Technical Service Bulletin: tsb101182

Released Date: 13-Sep-2002

One Piece Oil Filter Head Introduction

Figure 1 shows the old design and figure 2 shows the new design.

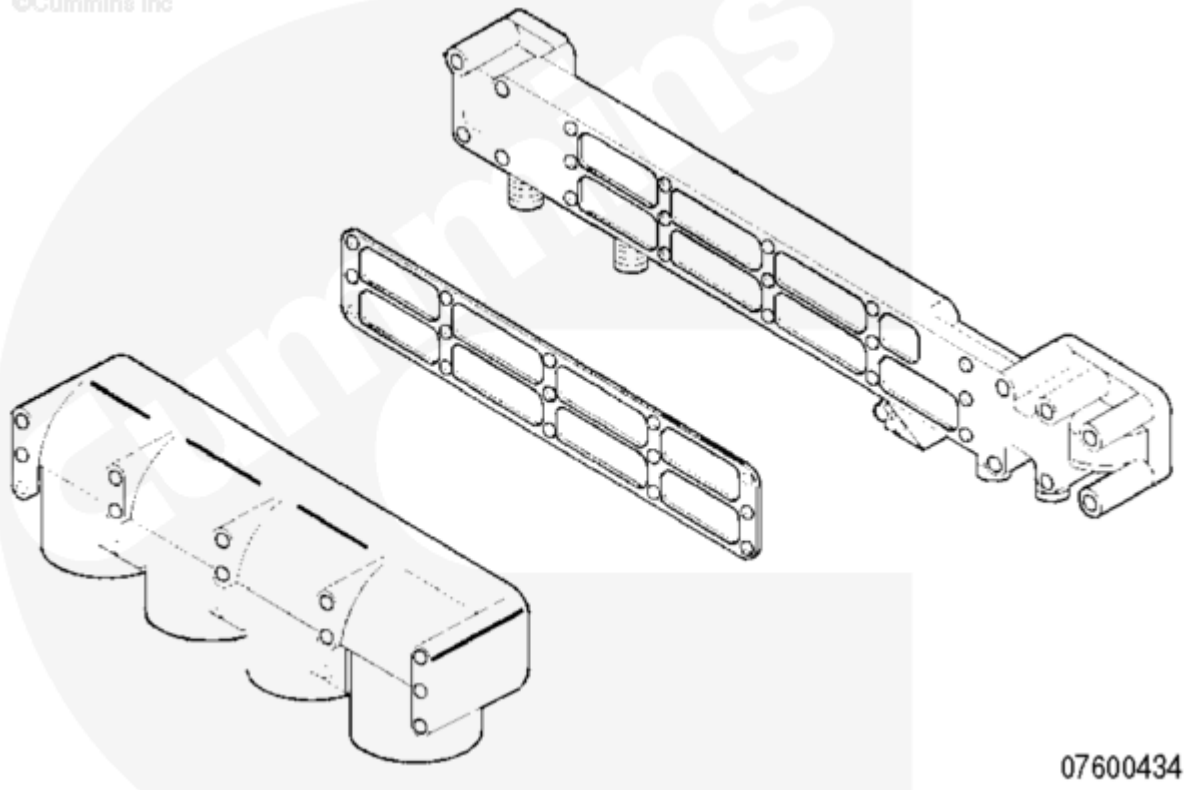
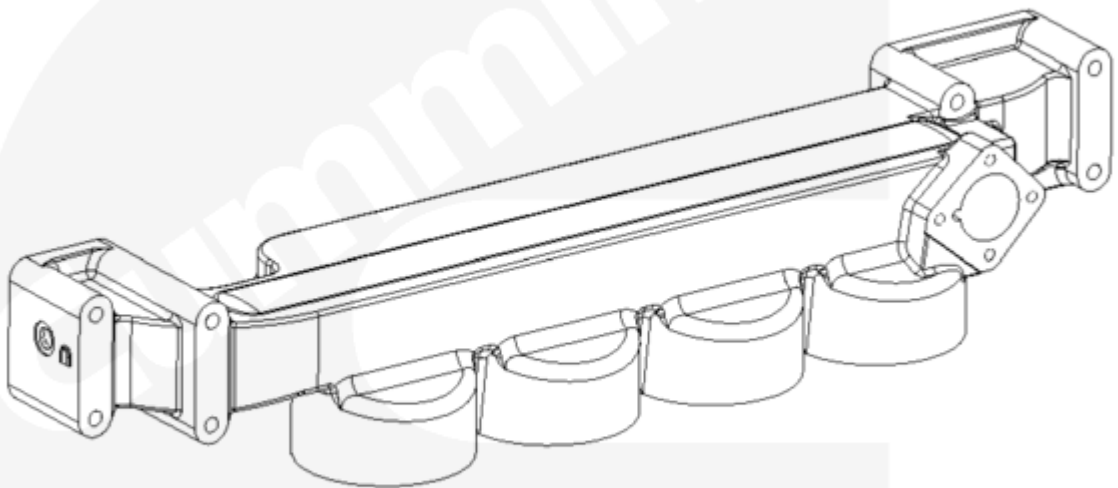
This service/parts topic obsoletes SPT01T7-12 and introduces a new one-piece oil filter head design for the QSK45 and QSK60 engines. Replace SPT01T7-12 with this one. The old design is a two piece assembly consisting of a back plate which attaches to the cylinder block and a filter head that attaches to the back plate. The new oil filter head is a one-piece design that bolts directly to the block eliminating the joint between the filter head and the back plate. The QSK45 oil filter head mounts three oil filters, the QSK60 oil filter head mounts four oil filters. The old two piece filter head has been obsoleted and replaced with the new one-piece filter head. If you order either of the old part numbers you will automatically receive a complete assembled one piece filter head.

Other differences in the design include the amount of mounting capscrews; the new design uses eight instead of ten like the old design. The position of the CENSE™ post-oil filter pressure sensor on the QSK60 has moved from the rear of the oil filter head facing vertically downwards. The new position is at the rear of the oil filter head facing horizontally toward the rear of the engine.

The new one piece filter head went into production at the Daventry Engine Plant for the QSK45 with engine serial number first 33151960. The approximate engine serial number first for QSK60 generator set engines is 33144999 and for industrial QSK60 is 33149441.

Fig. 3

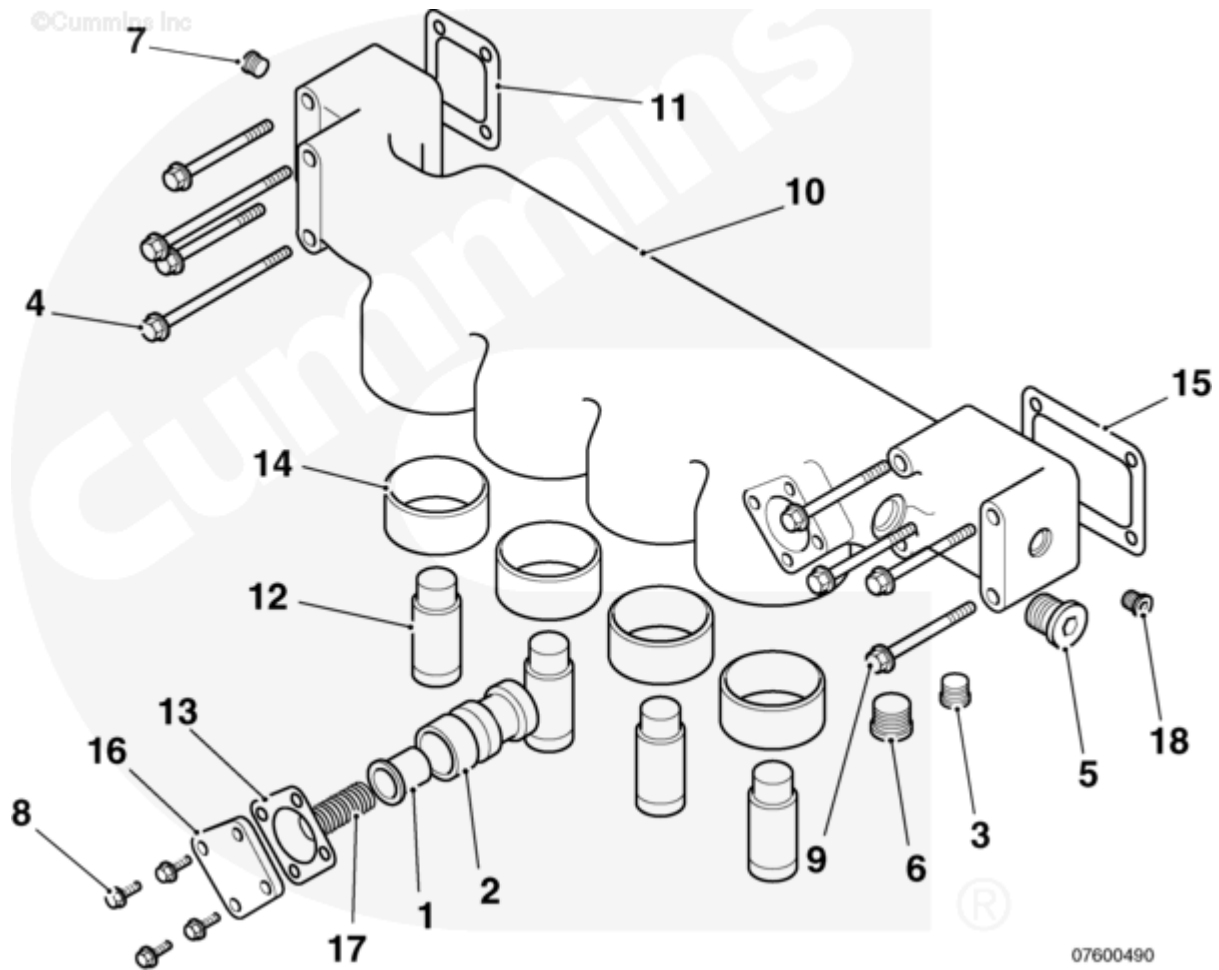
Item Number	Port Thread Size	Plug Torque	Use
7	M14	11 N•m	CENSE™ post oil filter pressure sensor location
6	M33	60 N•m	Connection for preluber
3	M22	27 N•m	Mini patch connection or pre oil filter pressure
5	M27	49 N•m	Post oil filter pressure
18	M14	11 N•m	CENSE™ pre oil filter pressure sensor location
